CITY OF ALBUQUERQUE

RE: **Los Pastores Shopping Center
Montgomery/Wyoming
Revised Drainage Report
Engineers Stamp Date: 6/11/2018
Hydrology File: F19D013C**

Drainage Management Plan Addendum

Los Pastores Shopping Center

CITY OF ALBUQUERQUE PUBLIC WORKS DEPARTMENT ENGINEERING GROUP	
TITLE: LOS PASTORES SHOPPING CENTER PAVING IMPROVEMENTS ALLEY "B" (WEST): STA: 25+15.00 TO 28+46.19	
DESIGN REVIEW COMMITTEE	CITY ENGINEER APPROVAL
LAST DESIGN UPDATE	
CITY PROJECT NO. 719880	
ZONE MAP NO. F-19-Z	
SHEET 8-1 OF 15

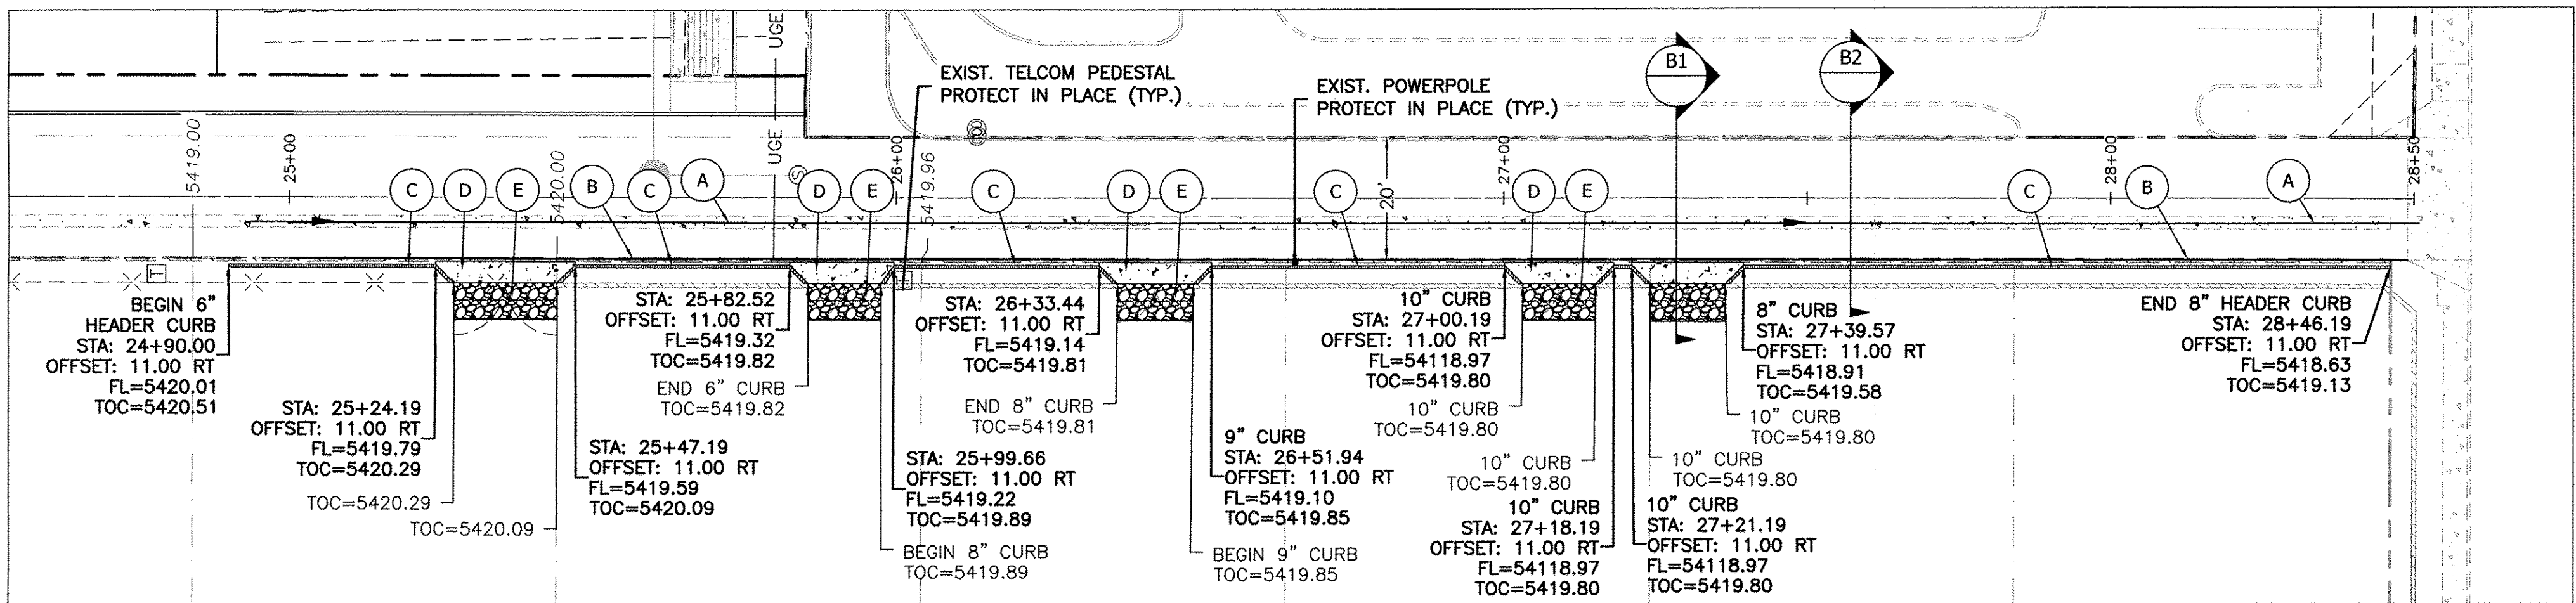
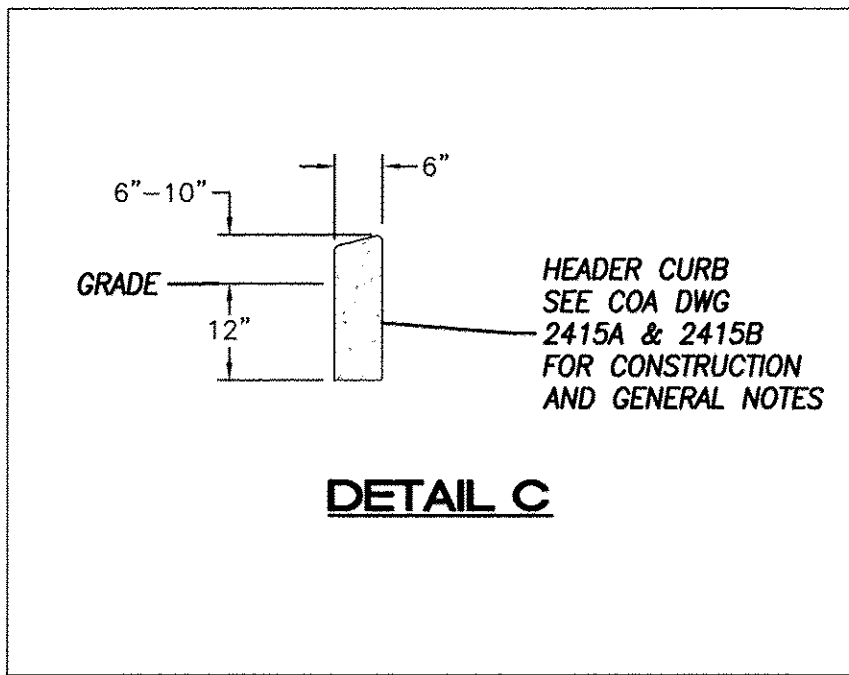
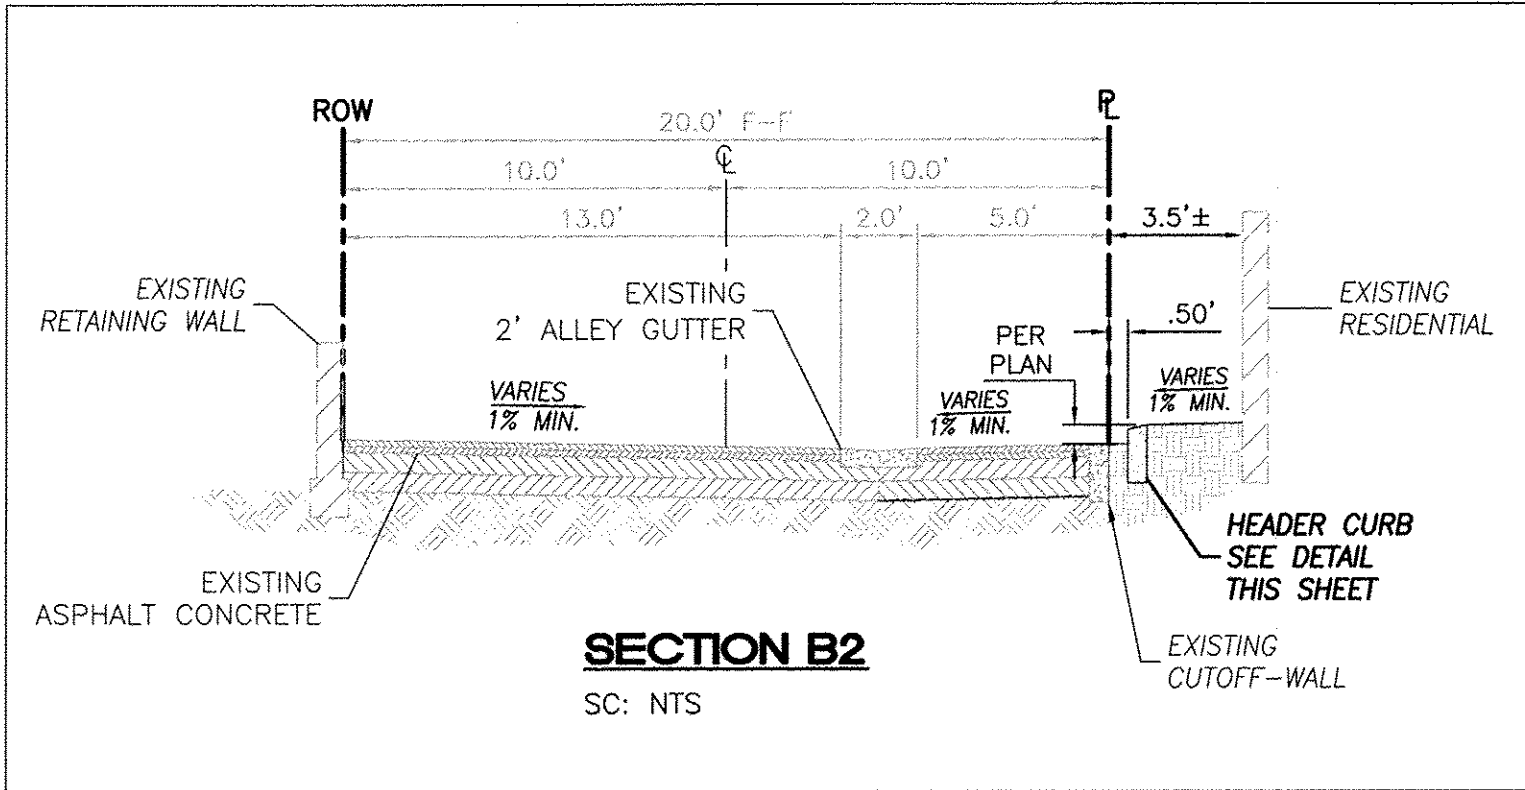
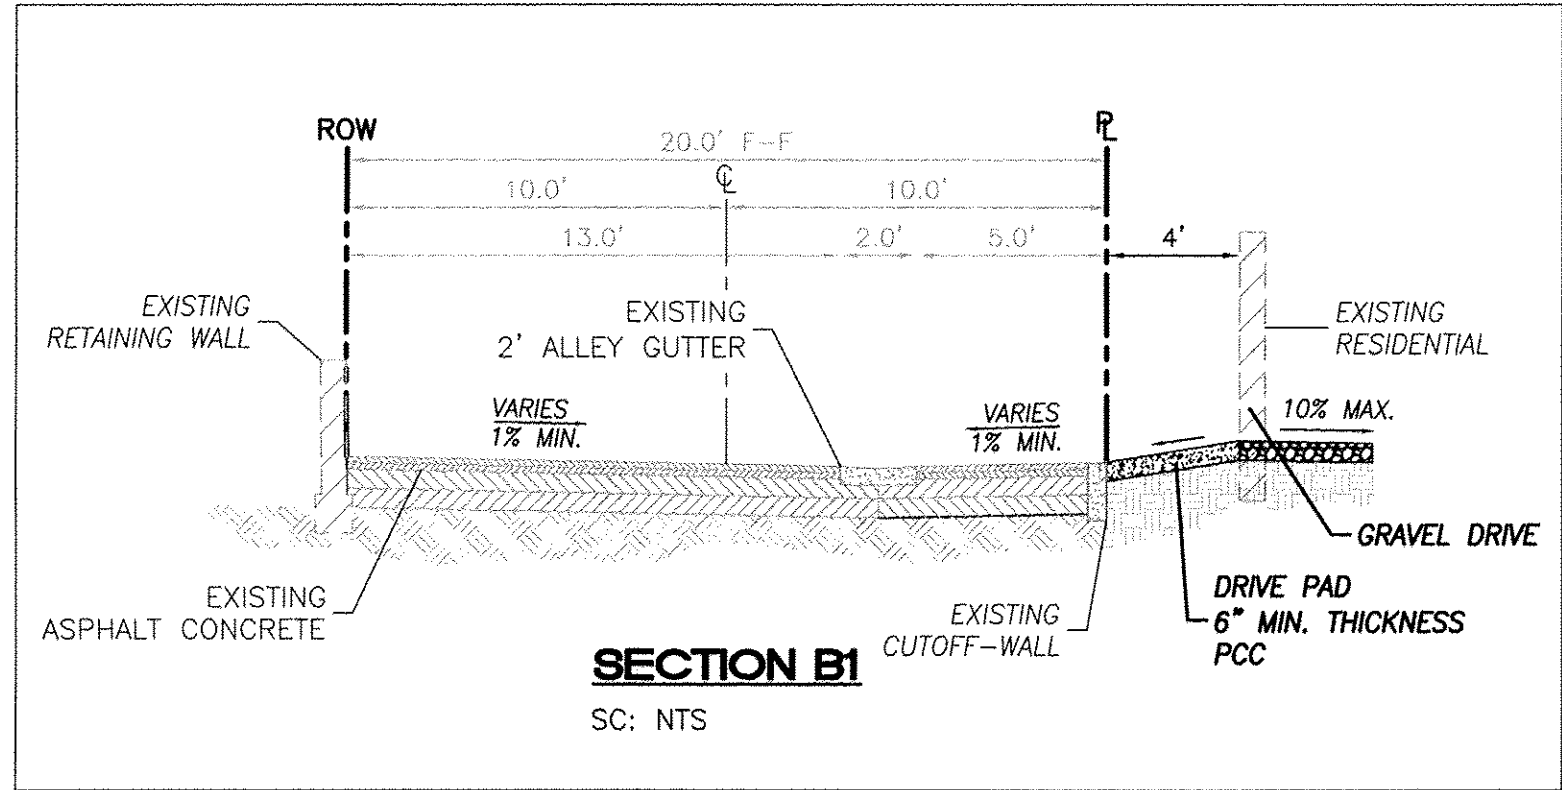
1. Permanent Public Easements must be recorded to contain the curbs, drive pads, and any necessary grading on the private residential lots west of the alley.
2. An Agreement and covenant must be recorded for maintenance of the curbs, drive pads, and grading on the lots west of the alley.
3. A Drainage Covenant is required for the maintenance of the storm water quality/detention pond.

4. It is unclear whether these changes are to be constructed as part of the current Los Pastores Shopping Center Work Order or if they are to be constructed by separate Work Order associated with the McDonalds redevelopment project. Either way the improvements should be shown on the McDonalds G&D Plan with references to which Work Order will be constructing the improvements. If the McDonalds redevelopment is responsible for the improvements then they must be listed on an Infrastructure List and approved by the DRB.

5. If the improvements are to be constructed as part of the Los Pastores Shopping Center Work Order, then revised plans must be submitted to DRC for all of the members to review and approve. Then a formal Change Order must be processed thru DRC.
